**ADDENDUM # 3
TO THE CONSTRUCTION DOCUMENTS
For
Lumber River State Park – Wire Pasture Access Development
SCO ID # 16-14432-01A
for the
Division of Parks and Recreation**

Date: July 25, 2024

The following changes, additions, and/or deletions are hereby made a part of the Construction Documents for the above noted project, fully and completely as if the same were fully contained therein. All other terms, conditions, drawings and specifications of the Construction Documents remain unchanged.

PLANS AND SCHEDULES
X1.01
SHEET OF

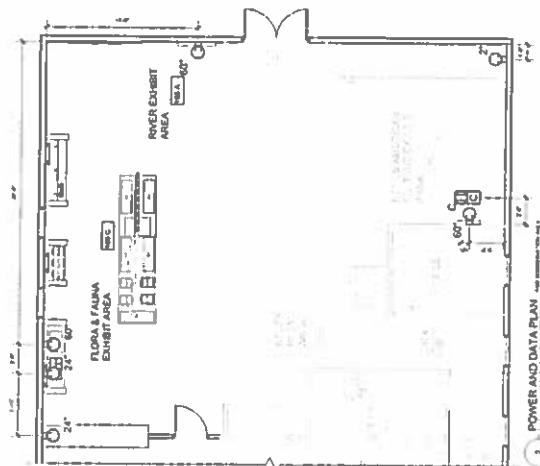
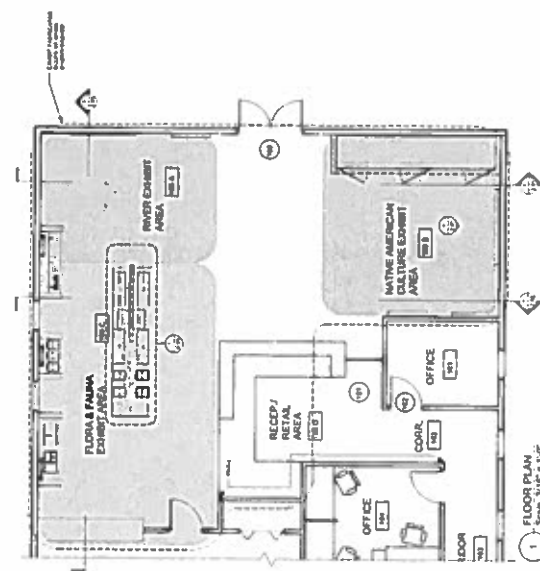
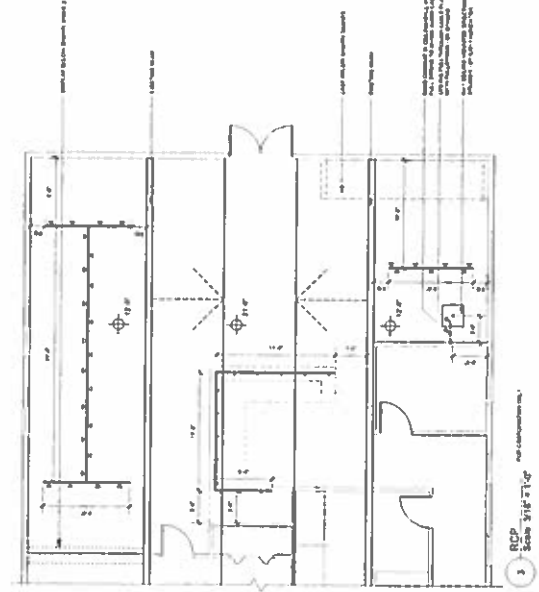
29. **Drawing X1.01: Graphic schedule on drawing X1.01 shows 6 quantities for 6.1 - 6.3 AG whereas detail 10 on sheet X4.01 shows 7. Please advise.**
Answer – Quantity should be 7 as shown on Detail 10 Drawing X4.01.
